TSTF-16-02
PROJ0753

SUBJECT: Response to NRC Request for Additional Information Regarding TSTF-542, Revision 1, "Reactor Pressure Vessel Water Inventory Control" and Submittal of Revision 2

Response to NRC Request for Additional Information Regarding TSTF-542, Revision 1, "Reactor Pressure Vessel Water Inventory Control"

Example Table of Drain Time by Penetration Flow Path Size and Initial Water Level

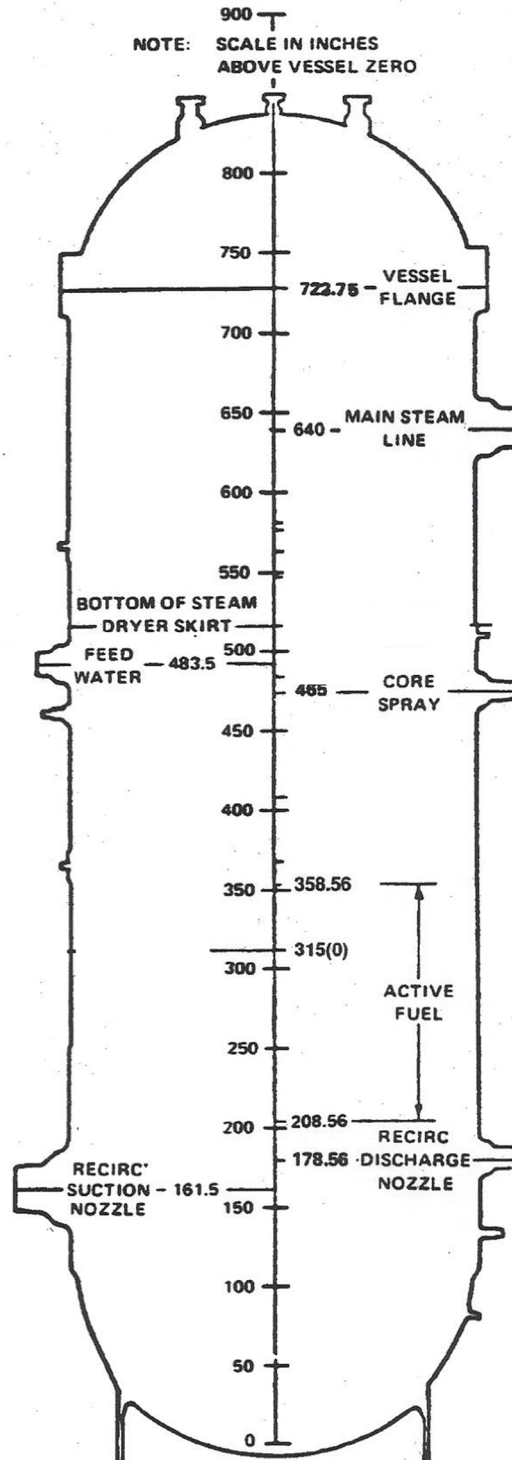
The response for Question #20 of the RAI regarding TSTF-542, Revision 0, states that licensees may choose to use a simple table or graph that provides a conservatively calculated (i.e., bounding) Drain Time for ranges of penetration flow path cross-sectional areas and water heights. The NRC staff requests that the simple table or graph recommended in the RAI response be provided. Additionally, the NRC staff requests a clarification regarding how the simple table or graph will be used in comparison to the Drain Time definition.

A bounding Drain Time table would be used by the plant operating staff to quickly determine a conservative estimate of Drain Time in order to respond to changing plant conditions. This conservatively estimated Drain Time would be used to enter the appropriate Condition of the proposed TS 3.5.2, "Reactor Pressure Vessel Water Inventory Control."

Alternatively, the licensee may choose to perform a more detailed calculation using the specific values for a penetration flow path. For example, the calculation could be performed using a discharge coefficient based on the physical flow path configuration, and the actual drain point elevation. The approach would most likely be used for planned maintenance.

An example table of Drain Time based on penetration flow path cross-sectional area and initial water height above the Top of Active Fuel (TAF) is provided based on an illustrative methodology¹ and the example BWR/4 Reactor Pressure Vessel (RPV) elevations shown in Figure 1.
